Upper House Committees, Legislative Council
Parliament of New South Whales

Council can provide the following supporting documentation in response to the questions on notice outlined within the transcript from the Public Works Committee Hearing in relation to the Impact of the Western Harbour Tunnel and Beaches Link on 13 September 2021.

**SUBMISSION FROM NORTH SYDNEY COUNCIL TO THE
DEPARTMENT OF PLANNING, INDUSTRY AND ENVIRONMENT
WESTERN HARBOUR TUNNEL AND WARRINGAH FREEWAY
UPGRADE ENVIRONMENTAL IMPACT STATEMENT
MARCH 2020**

Figure 6 – Land bridge concept

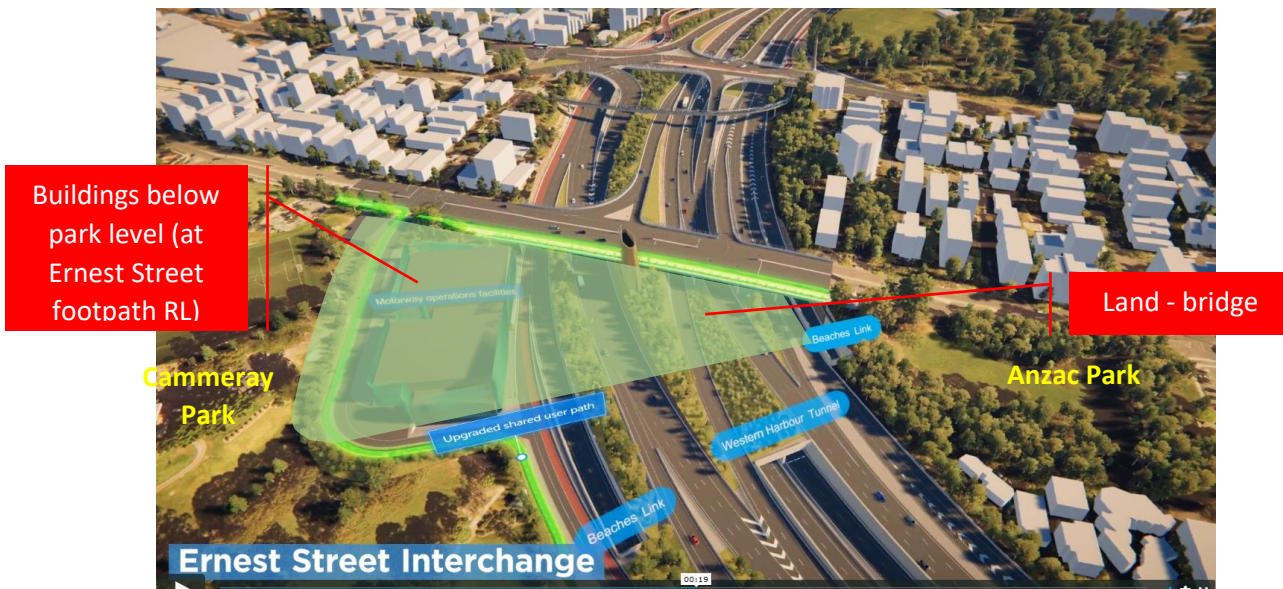
2. That a substantial land-bridge be constructed linking the south west corner of Cammeray Park with the western side of Anzac Park. The scheme in the EIS proposes a narrow green 'median' only as part of the 'shared user path' section of the reconstructed Ernest Street bridge. Rather, the land-bridge should seek to create a generous reconnection of open space parcels that were severed by the construction of the Warringah Freeway in the 1960s. Both of the above are conceptually illustrated below:

Figure 7 - Land bridge concept and suggested treatments

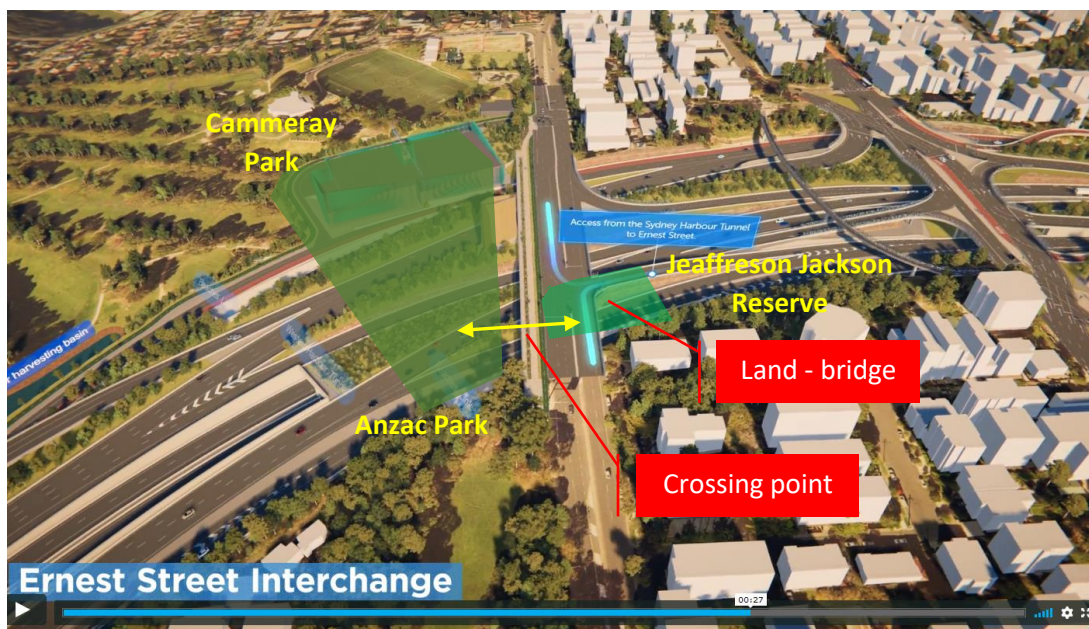
- That a further, smaller section of land-bridge be established if feasible where the Ernest Street off-ramp joins Ernest Street linking to the existing open space along the western side of the corridor, and a crossing point be established across Ernest Street at this point to the new land-bridge. This will assist to facilitate continuous pedestrian & open space corridor through to Jeaffreson Jackson Reserve to the south and towards St Leonards Park, as illustrated below:

Figure 9 - Location plan of acquisition sites – Morden and Bellevue Streets Cammeray

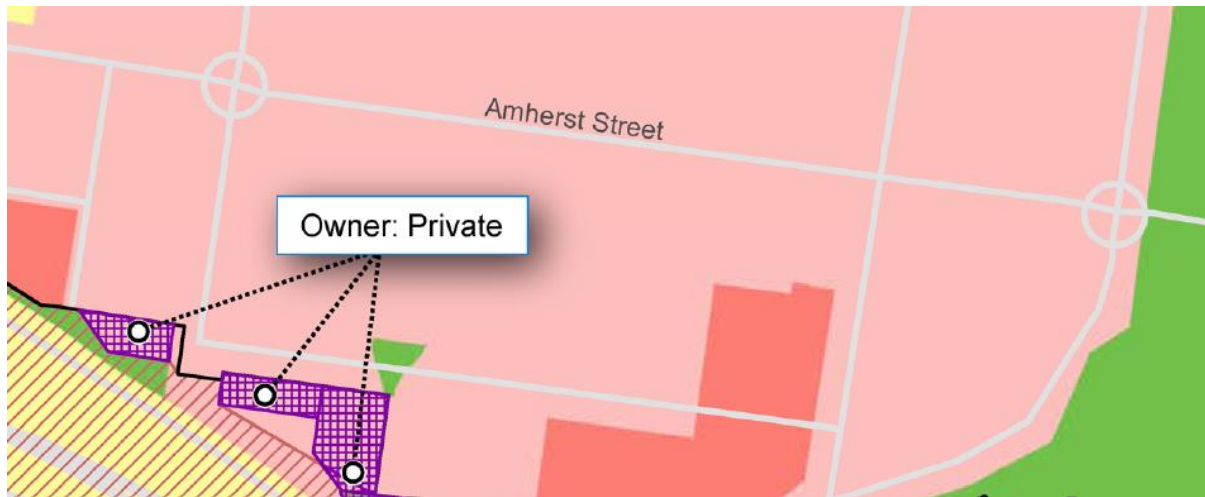
A residential flat building comprising twelve (12) units on Morden Street at Cammeray would be fully acquired and demolished for use during construction. Following construction, the site would be re-habilitated with an undetermined future use and ownership.

Two (2) residential dwellings on Bellevue Street Cammeray would also be fully acquired and demolished for use during construction. Following construction, the sites would be re-habilitated with an undetermined future use and ownership.

Figure 10 - Ernest Street – partial acquisition

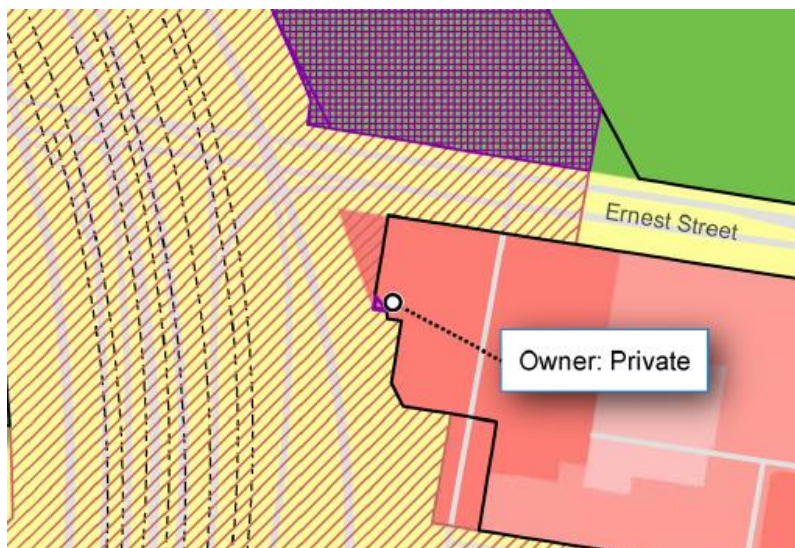
A section of privately owned residential property (refer Figure 10 above) would be permanently acquired for the permanent road works. The area the subject of acquisition is not specified but is described as being around 5% of the total property area. No qualitative description has been provided with respect to impact.

Figure 11 - Existing & Proposed Noise Barriers - WHT EIS Appendix G (Part 1), pages. 536-538.

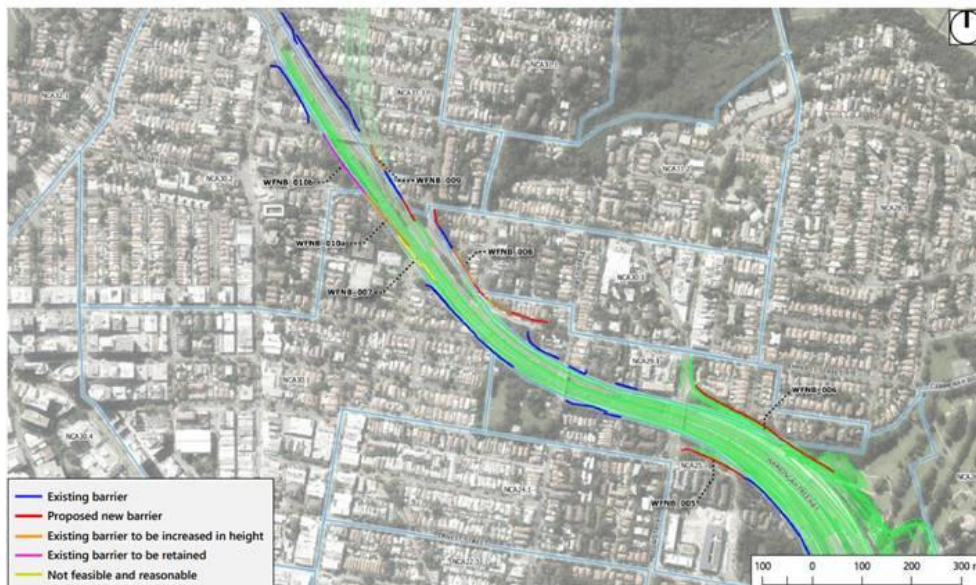
Further assessment has been conducted to compare the ‘Do minimum’ and the ‘Do something cumulative’ scenarios, including proposed low noise pavement and proposed new and existing extended noise barriers.

Figure 13 - Predicted severity of impacts to landscape character and views in the EIS are likely to be underestimated (amended from Figure 4.12 in Appendix V).

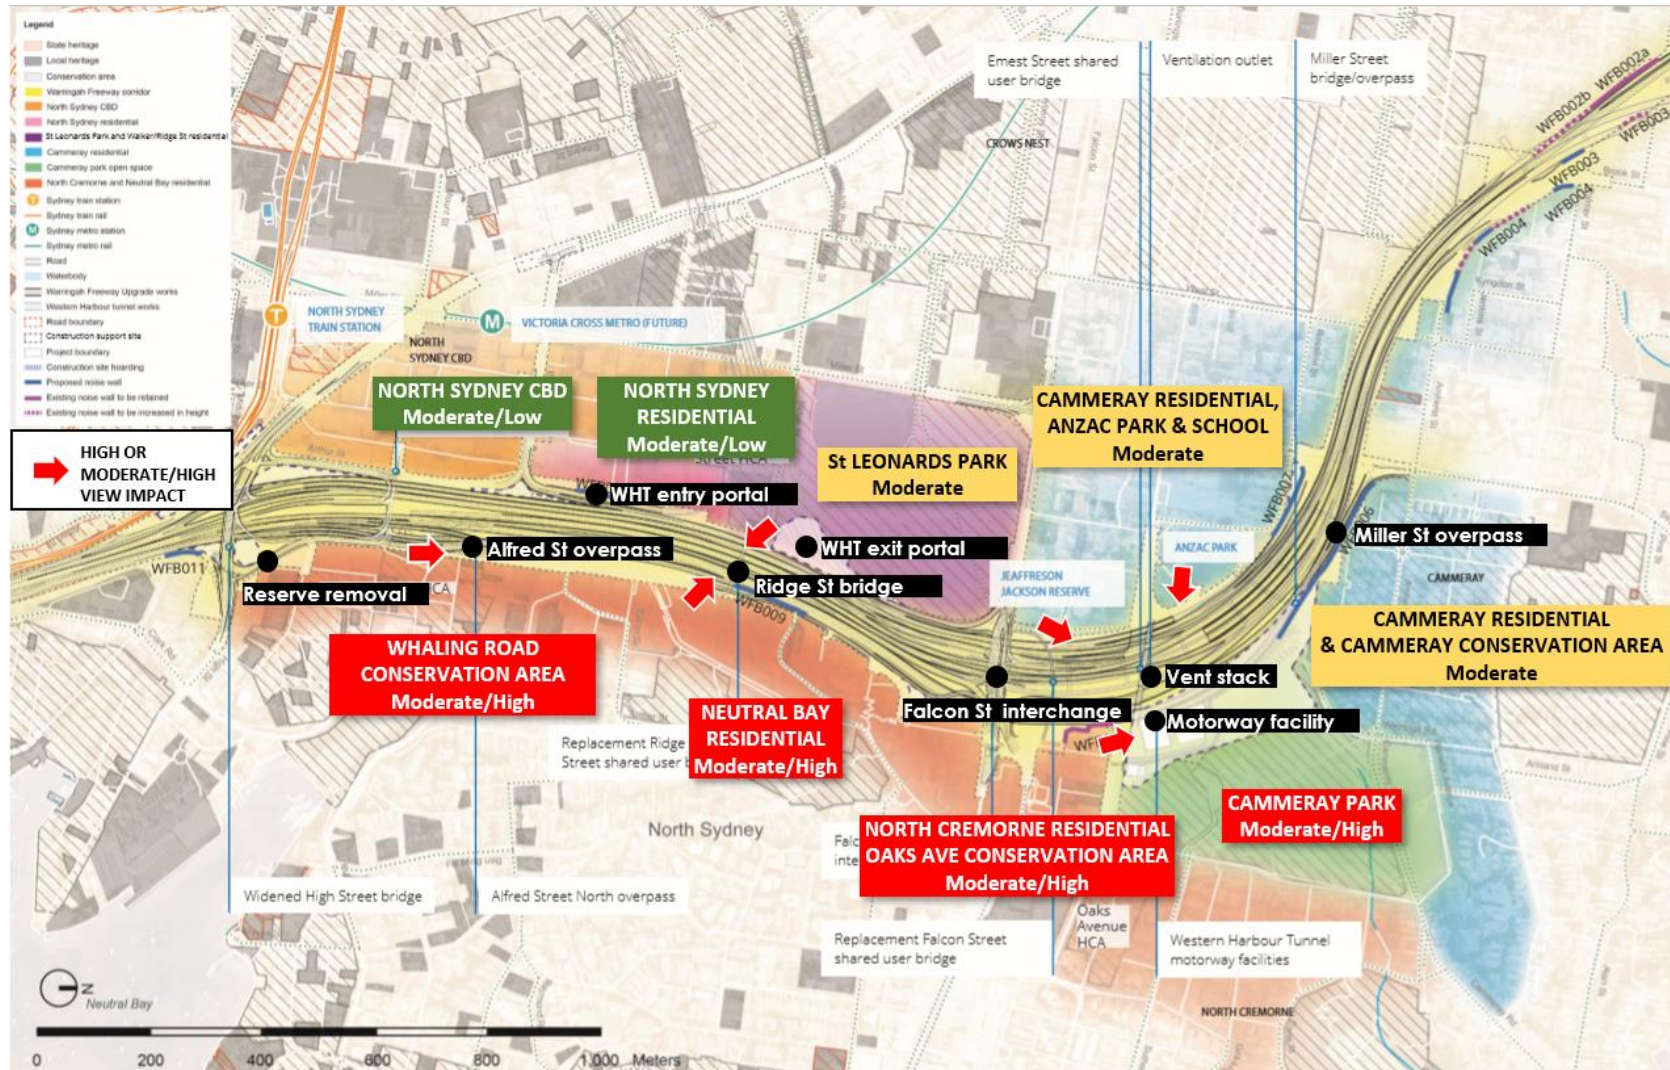
The EIS has classified the long-term project effects on the landscape character along the eastern side of the freeway, as ‘**Moderate/High**’ and either “**Moderate/Low**” or “**Moderate**” along the western side. It also identifies six locations of “**High**” or “**Moderate/High**” visual impacts at the Whaling Road Conservation Area, Ridge Street Lookout, Jefferson Jackson Reserve, towards Cammeray Park and Anzac Park (Figure 13).

Figure 17. The landscape character impact of the Miller Street overpass rated “Moderate” in the EIS.

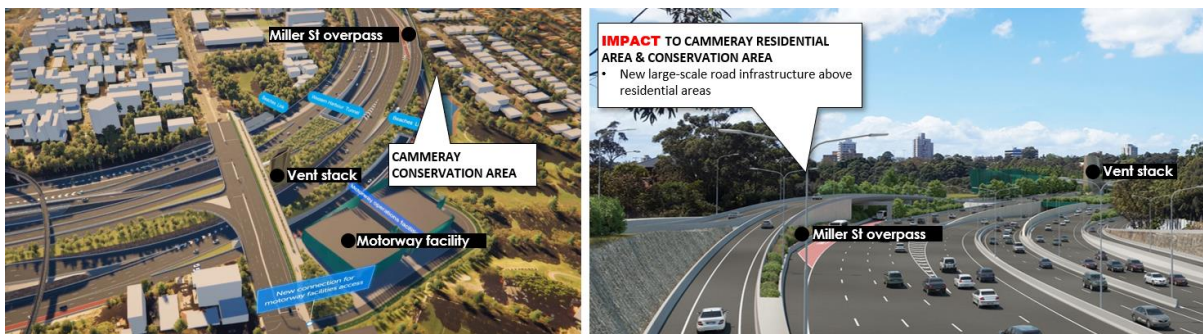
Similar road infrastructure is proposed for the Miller St overpass, however the EIS provides limited information or diagrams to show its possible impact on the Cammeray Conservation Area. Figure 17 shows screenshots taken from the Transport for NSW website which show how close the overpass will be to homes but obscures the height of the built form. The EIS categorises the impact to the landscape character as “**Moderate**” however, having regard to the photomontage for Alfred Street, it is likely to have a greater impact than this.
